ADDENDUM #2

FOR
RIPON ELEMENTARY SCHOOL: PARKING LOT
FOR
RIPON UNIFIED SCHOOL DISTRICT
Bid Time and Date: September 30, 2026 at 3:00 p.m.

ADD-2.1

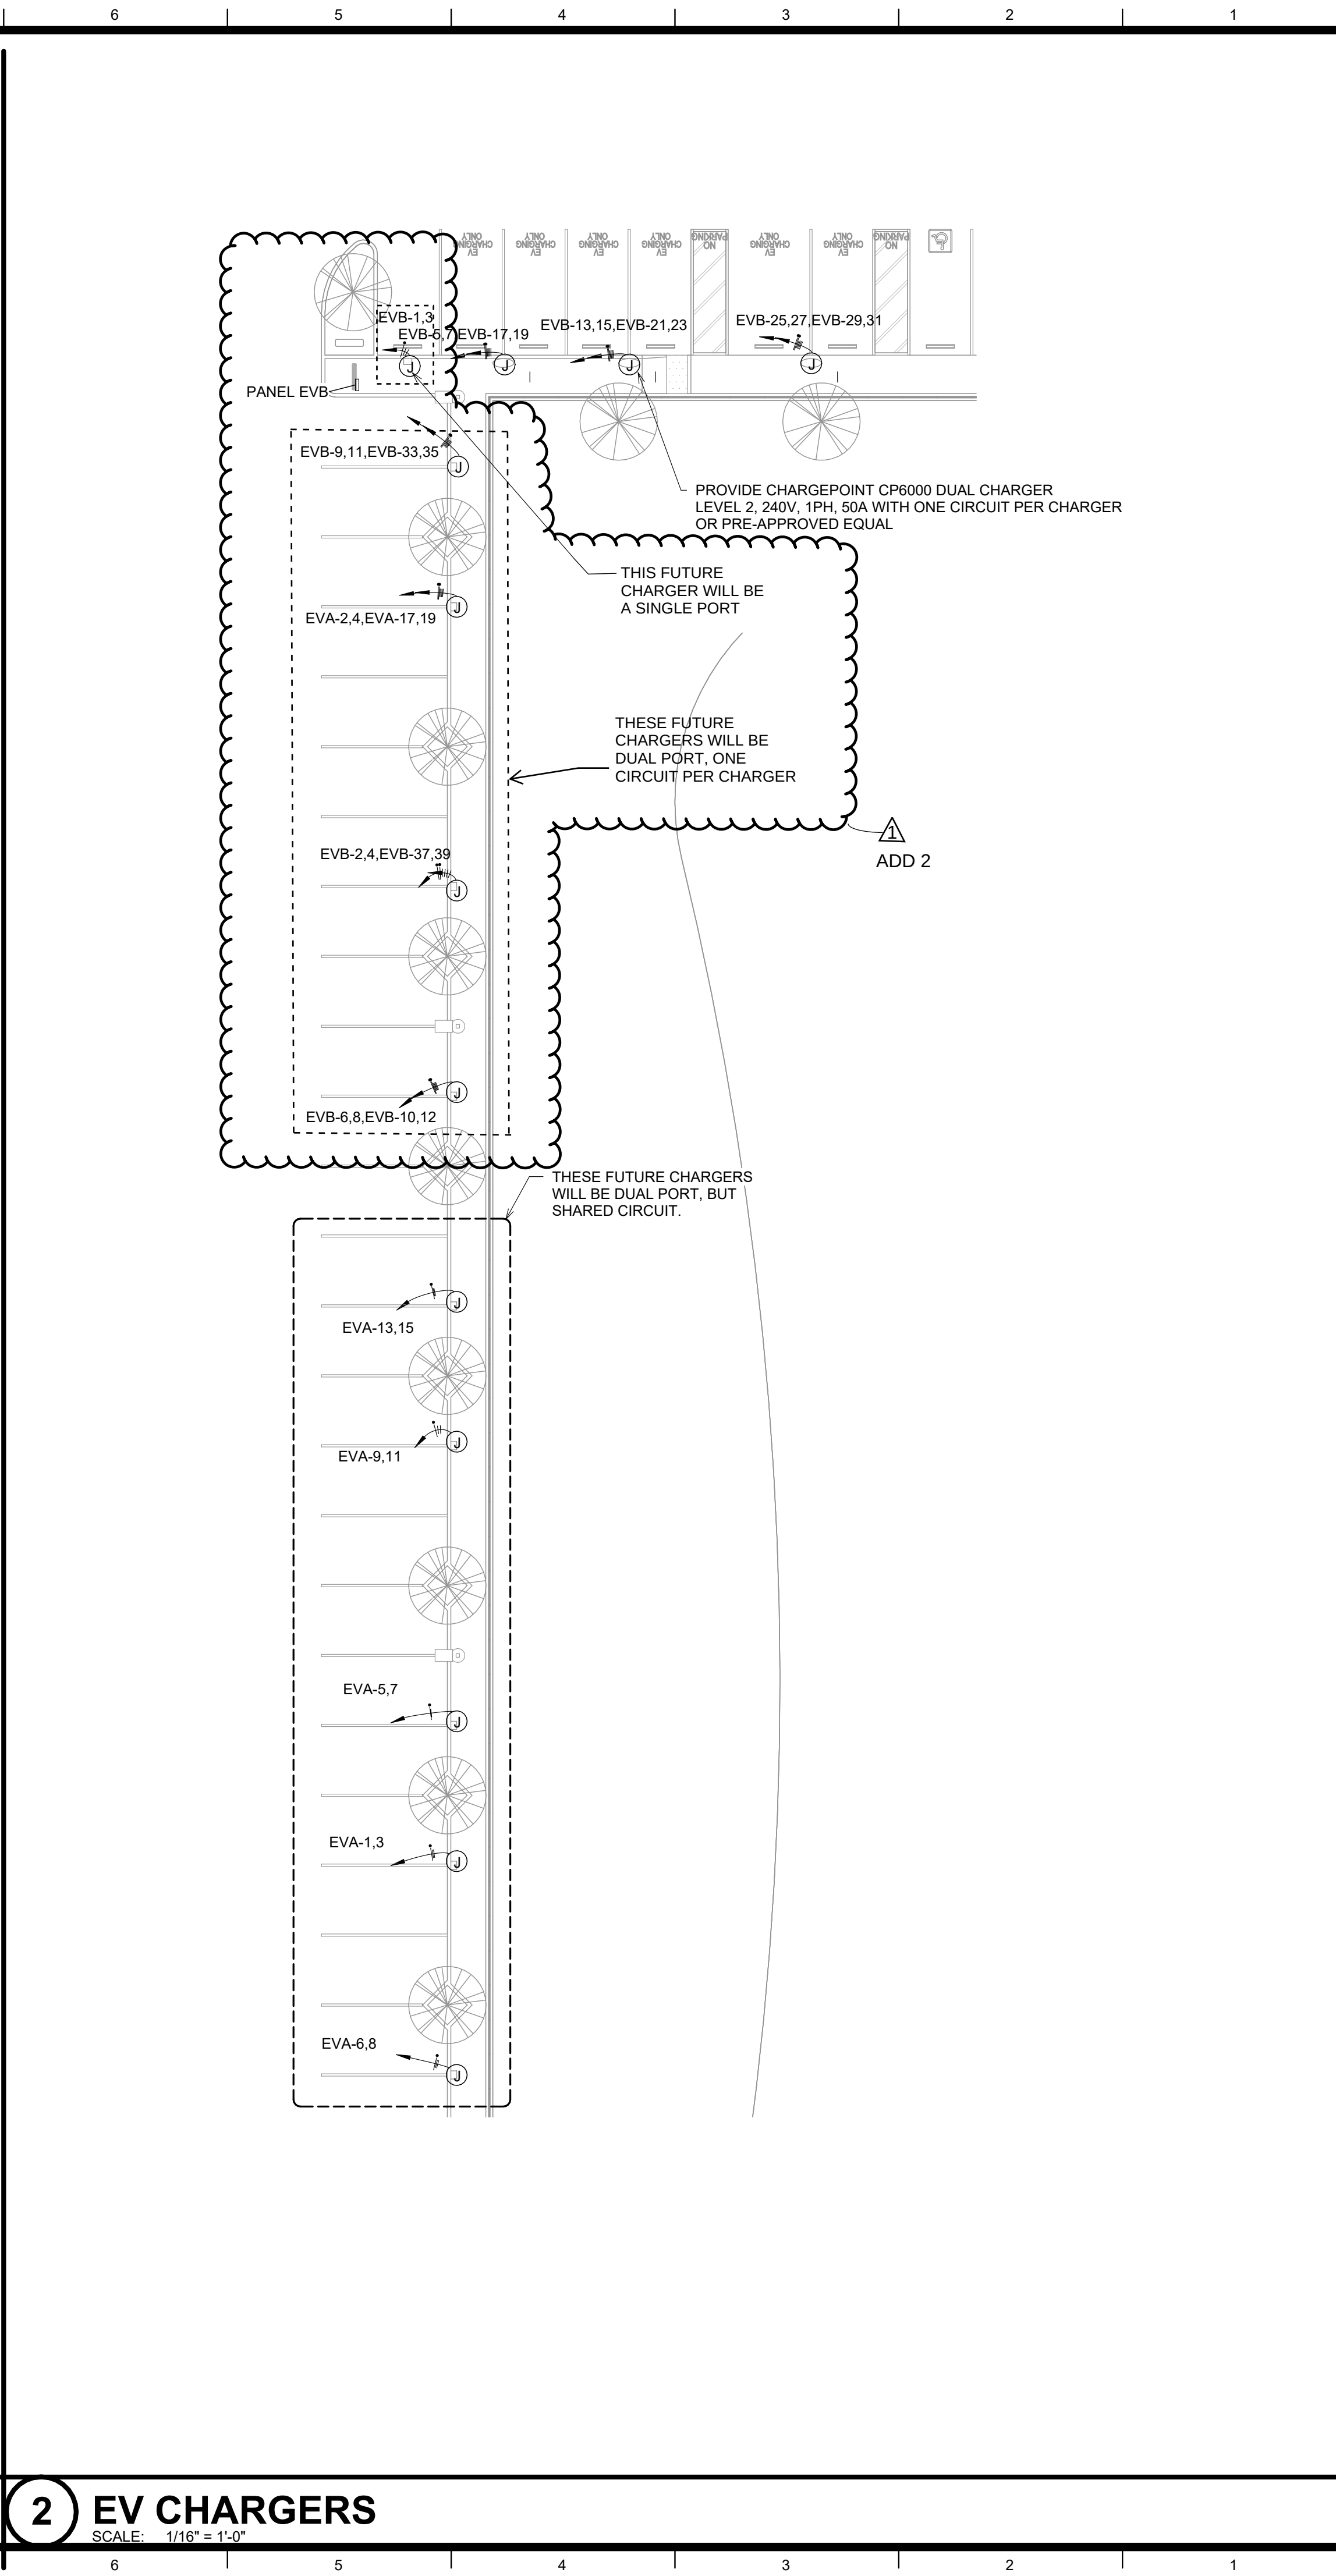
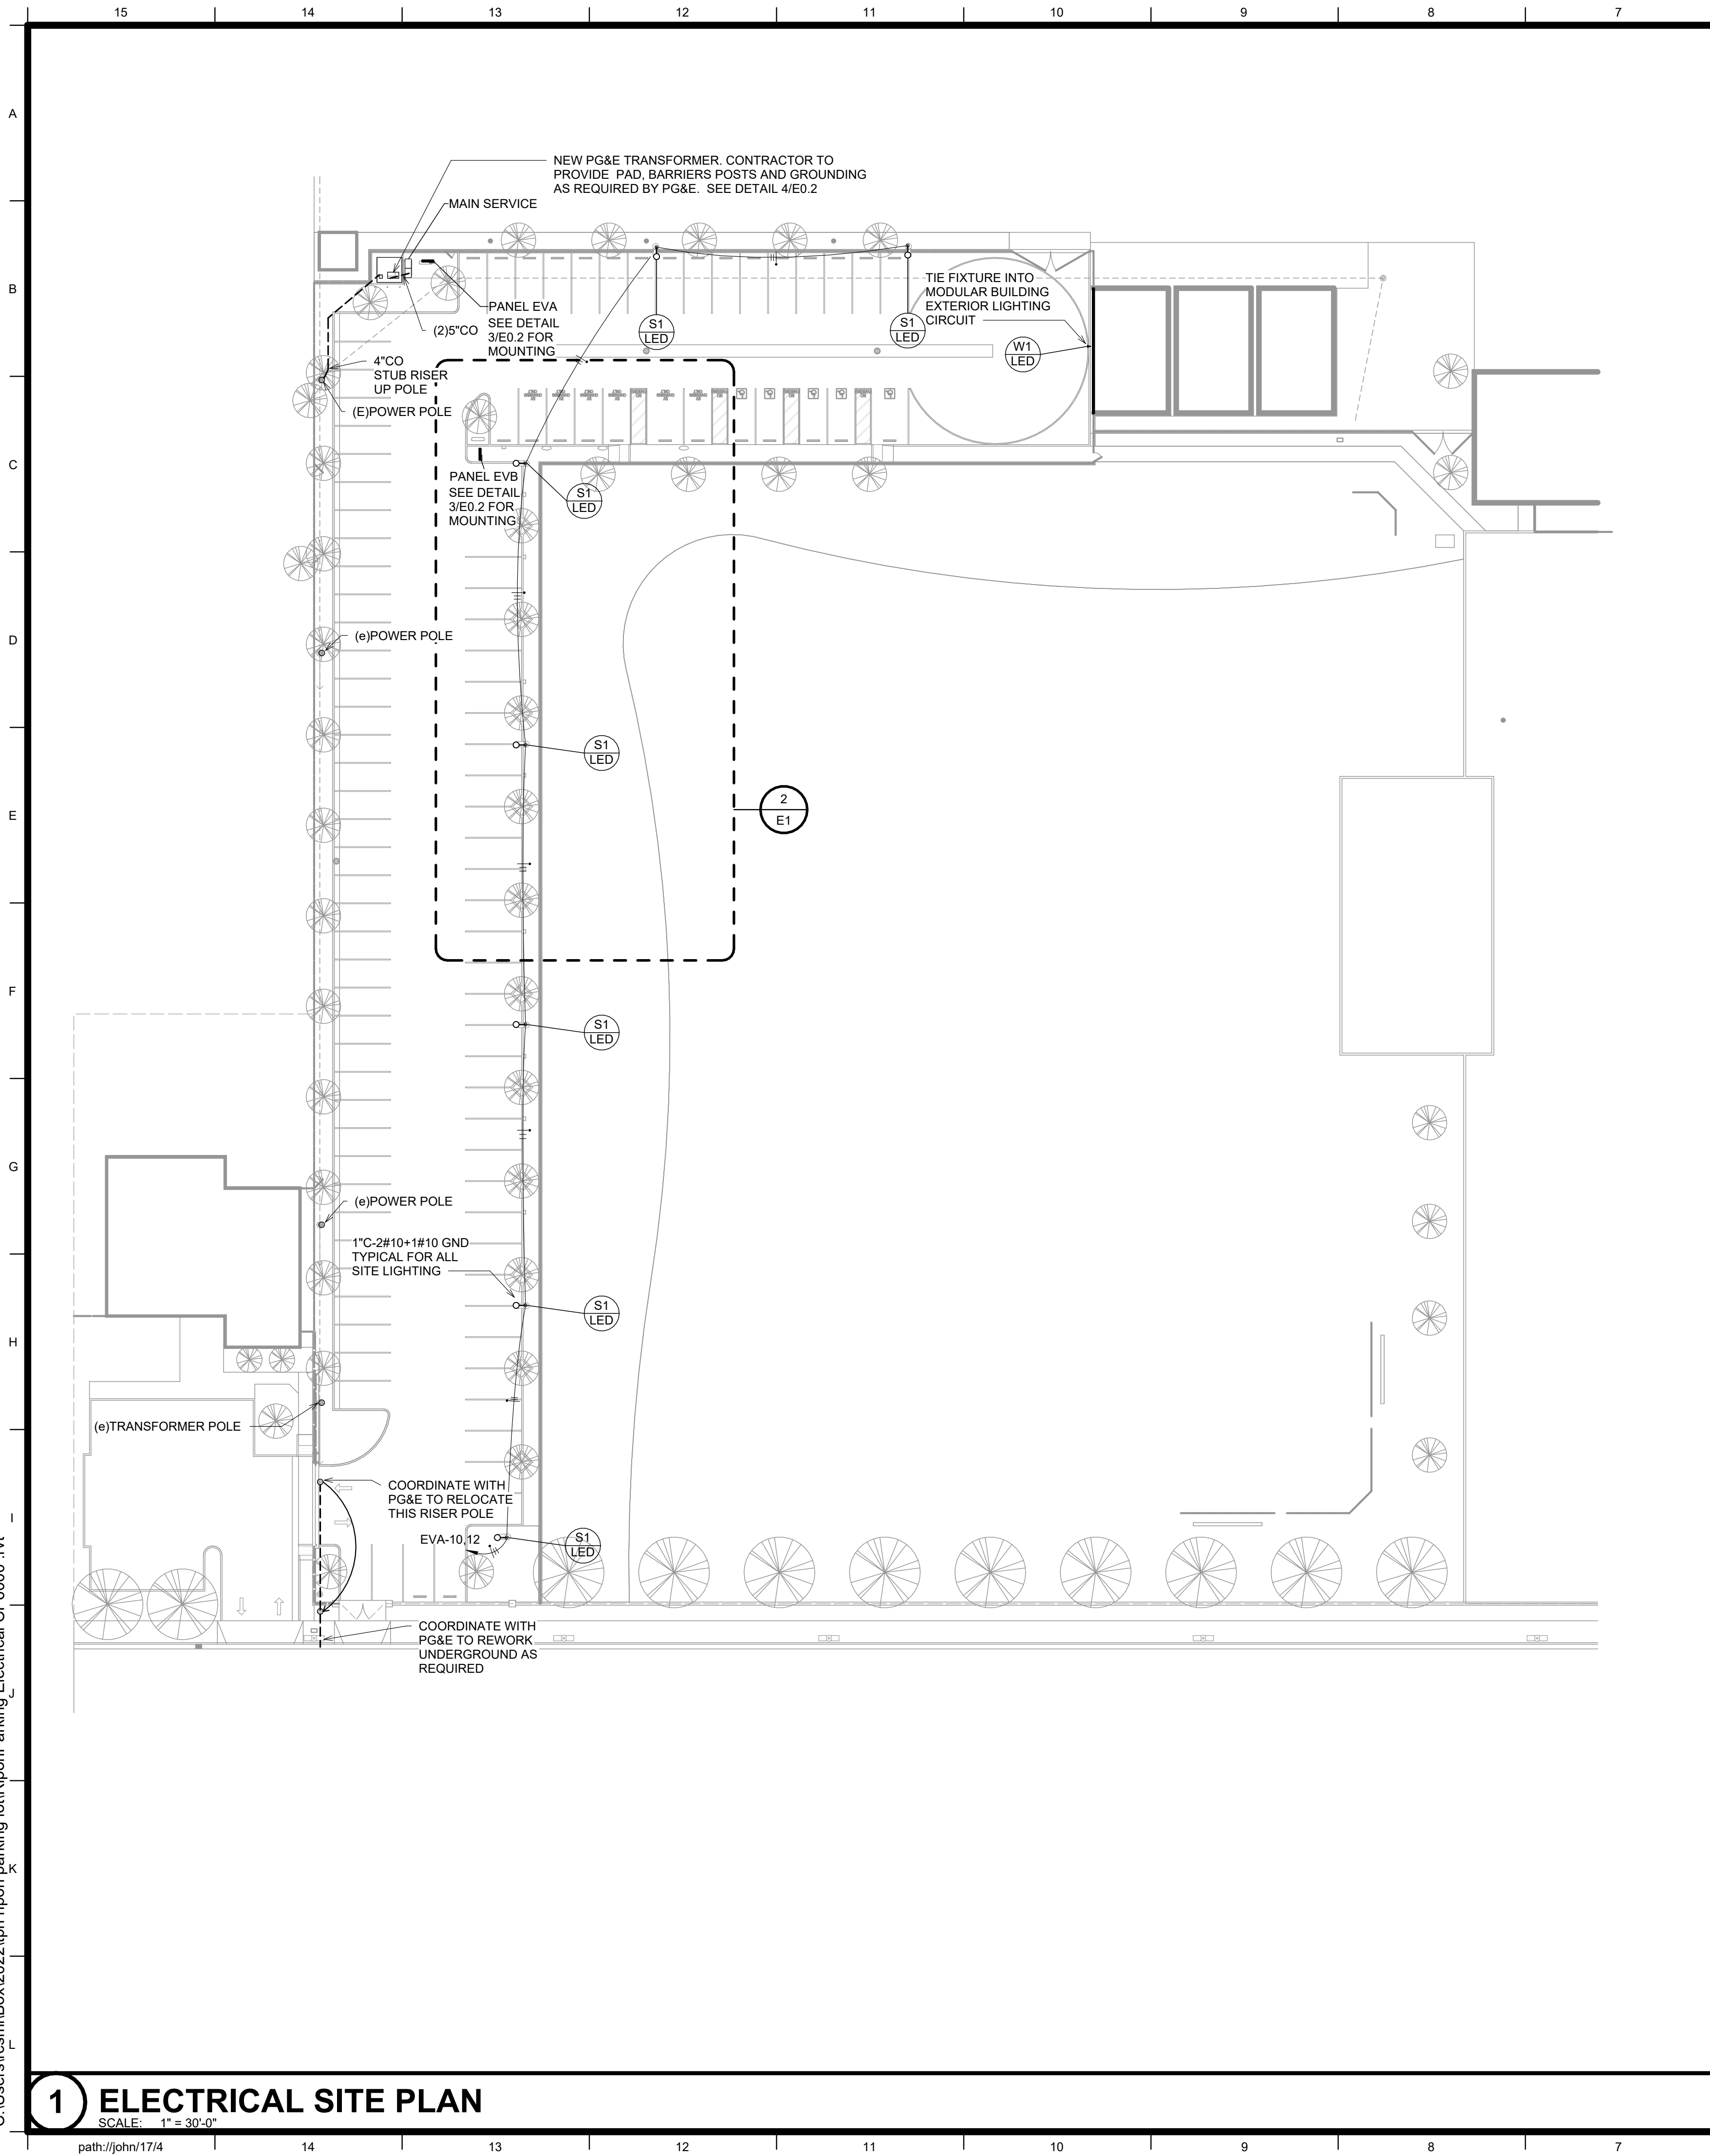
- Item 1.: Reference Sheet C3– Existing Storage Container:
For Clarification – The existing storage container in the north west corner of the site is to be relocated by the contractor to another location on the High School site.
- Item 2.: Reference Sheet E1 – Relocated Pole:
Relocate data lines on existing pole. See attached sheet ADD-2.1.

1. The electrical contractor shall coordinate the pole relocation shown on the electrical plans. As part of this coordination, the electrical contractor shall coordinate with PG&E, phone and cable tv providers for the pole removal. This shall include the communication cables and spliced cans shown in this picture.
